THREE MILE ISLAND NUCLEAR STATION UNIT 1

Operating License No. DPR-50  
Docket No. 50-289  
Technical Specification Change Request No. 5 Amendment No. 3

Technical Specification Change Request #5 Amendment 3

MET-ED CORPORATE TECHNICAL SUPPORT STAFF  
AND STATION ORGANIZATION CHART

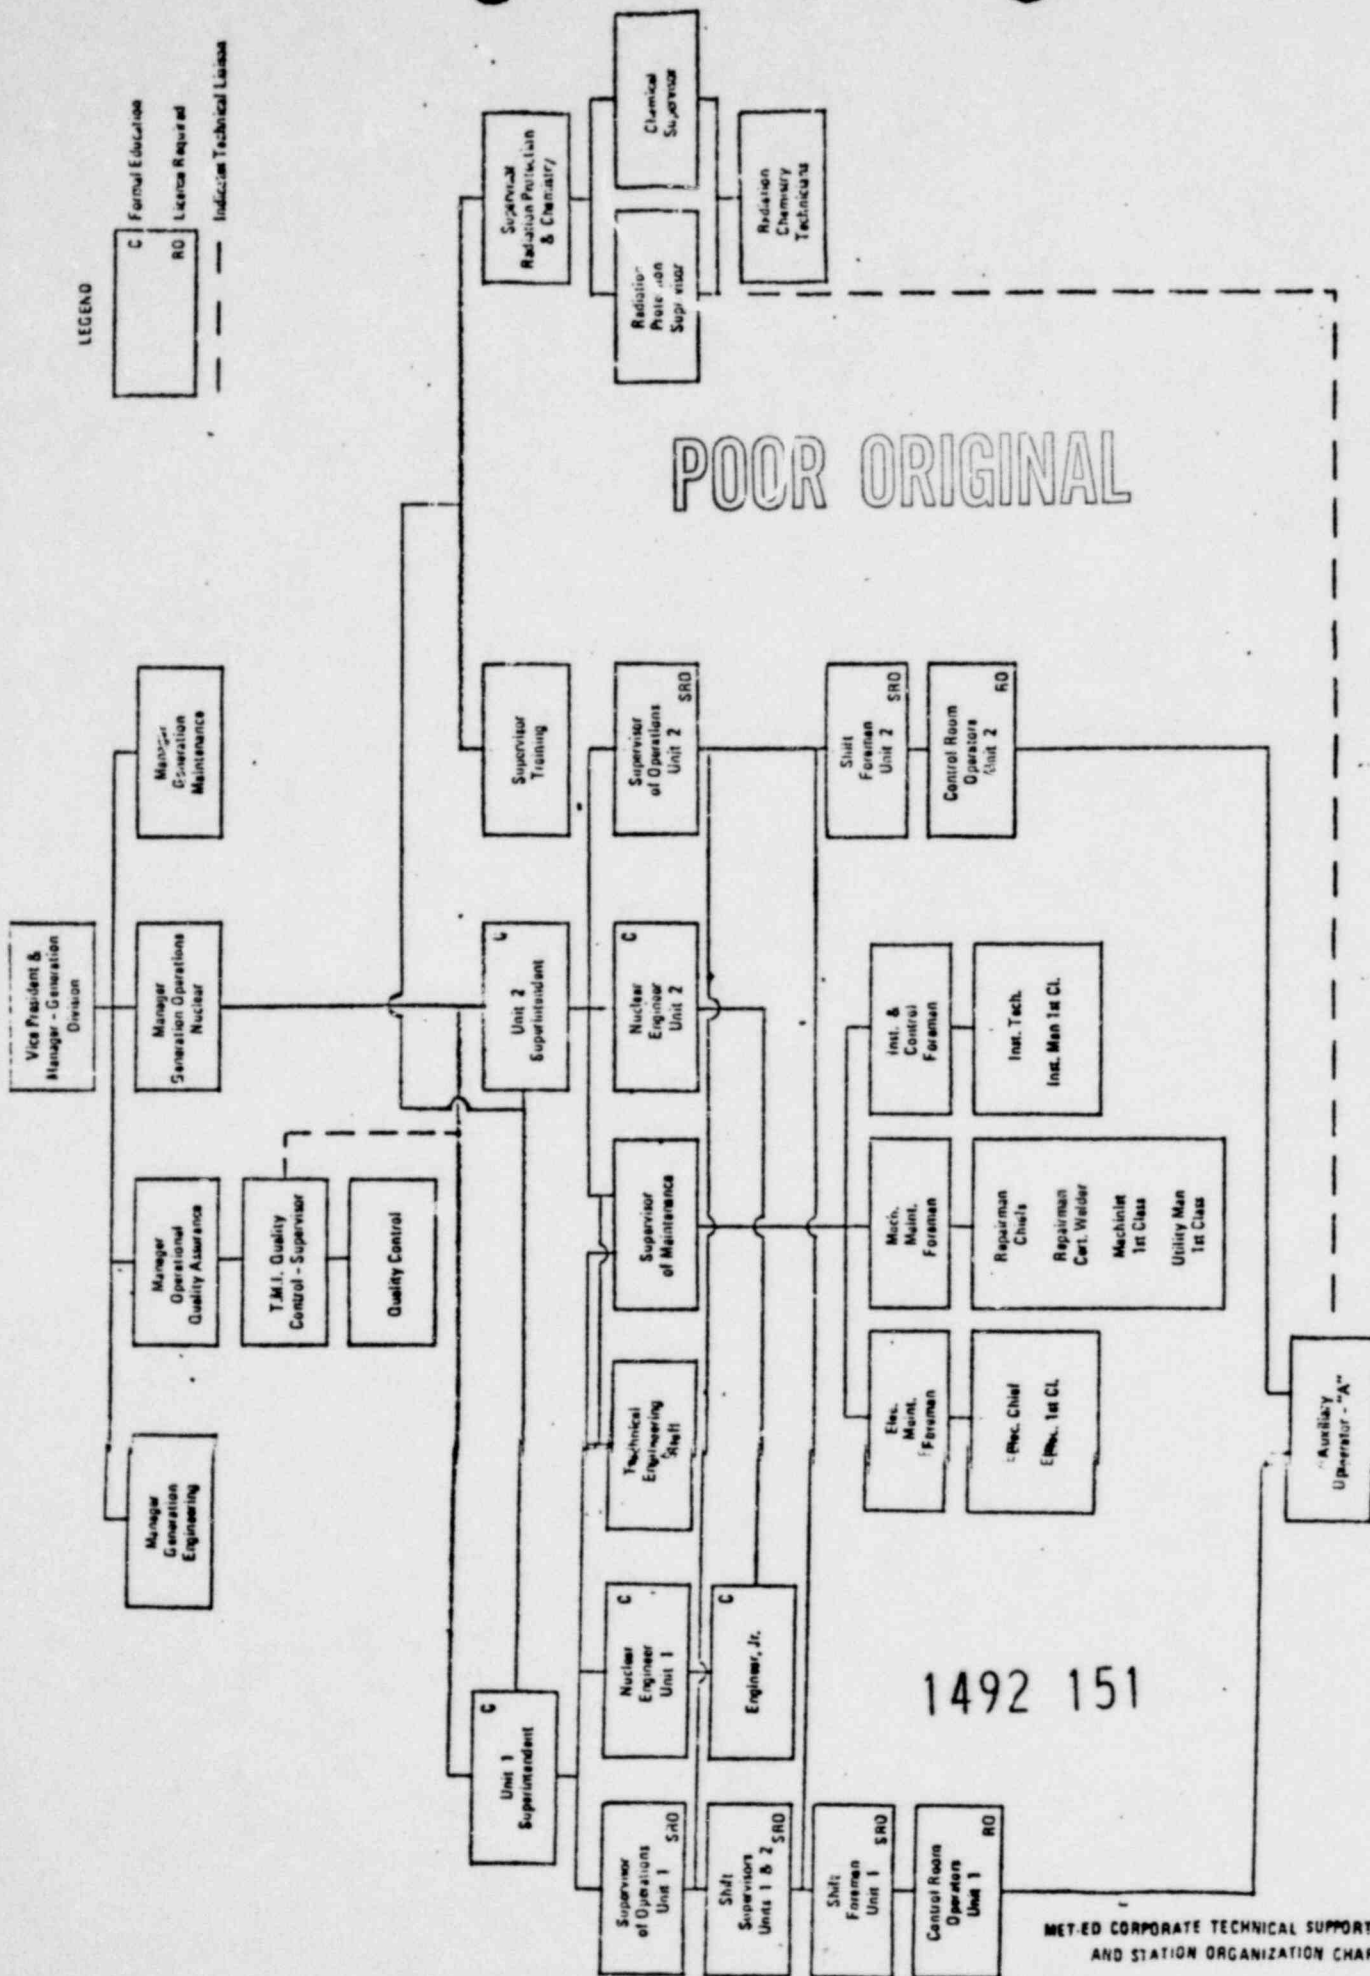
6.2.1 The organization of the Met-Ed Corporate Technical Support staff for Station management and technical support shall be as shown in Figure 6-1.

6.5.2.A.1 The organization of the Met-Ed Corporate Technical Support Staff is as shown on Figure 6-1 and consists of the Manager-Generation Operations Nuclear, Manager-Generation
